On behalf of the Beaufort Rd residents.

In addition to all of our objections made to date, we would like to confirm with more detail our objections relating to Visual Amenity and MOL VSC justification.

MOL and Very Special Circumstances Justification

Selection of Photographs from numbers 40, 34 and 32

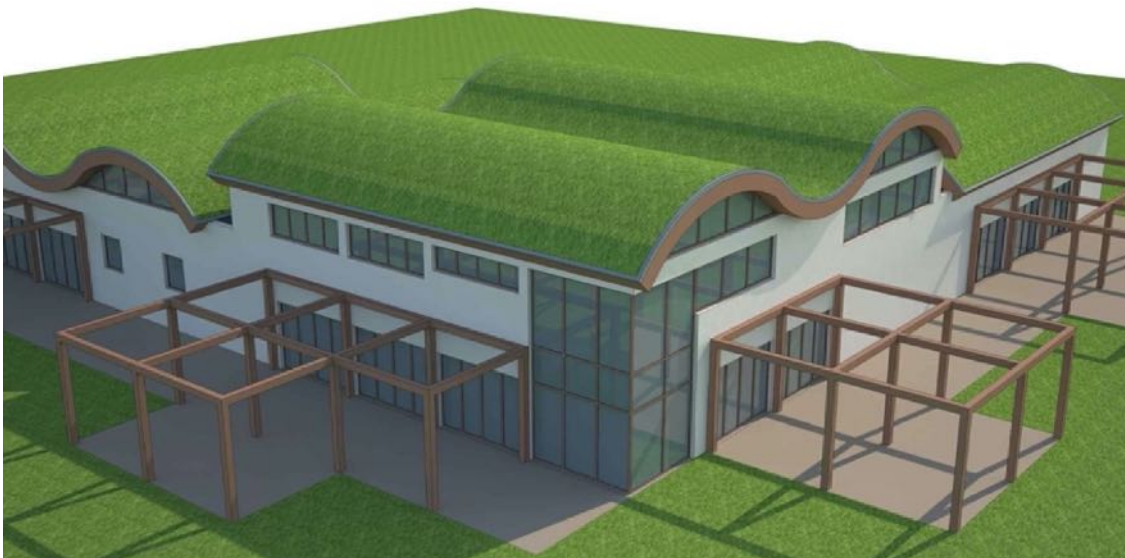
Within the Application and associated third party documents, no perspective is given as to the size of the building within the plot or the proximity to residents, which we feel places us at a severe disadvantage. As the Council cannot enter our properties to make any visual assessment, we have included below a selection of photographs from numbers 40, 46, 34, and 32 Beaufort Rd, along with a 3D model of the proposed structure. If required, we can also share with you the detailed elevation diagram our architect created from the draft sketches in the Application.

Diag A

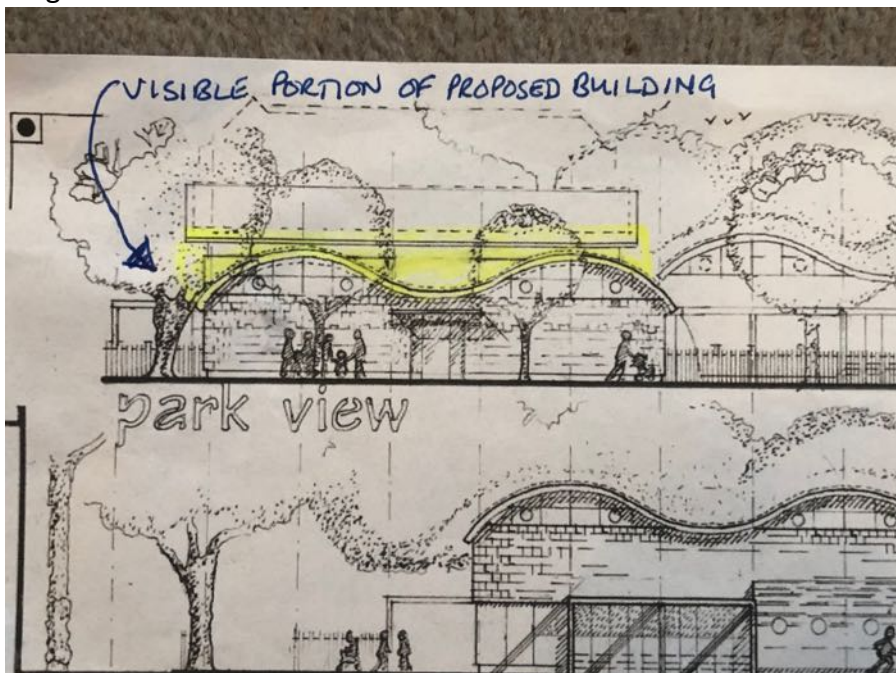
“Elevations Park View” - The Sketch does not show the true extent of the resulting sight line from the park, of a building that at the rear (next to Beaufort Rd) rises to 6.78m high - marked in Yellow (Diag A)

Diag B

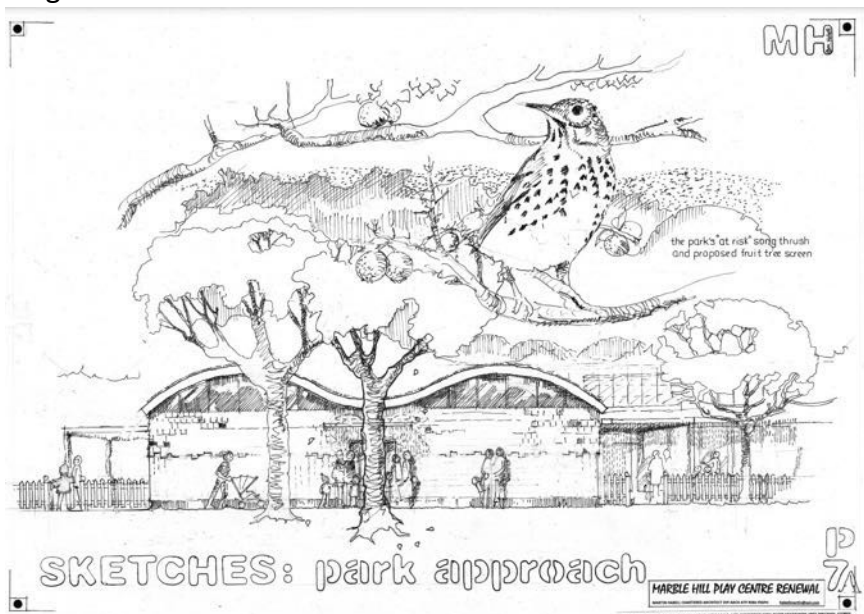
“Park Approach Sketch” This sketch provides an example of the draft nature of this Application, lacking clarity and detail whilst not representing the true view from the Park as the 2nd storey of the proposed building is not shown. (Diag B).
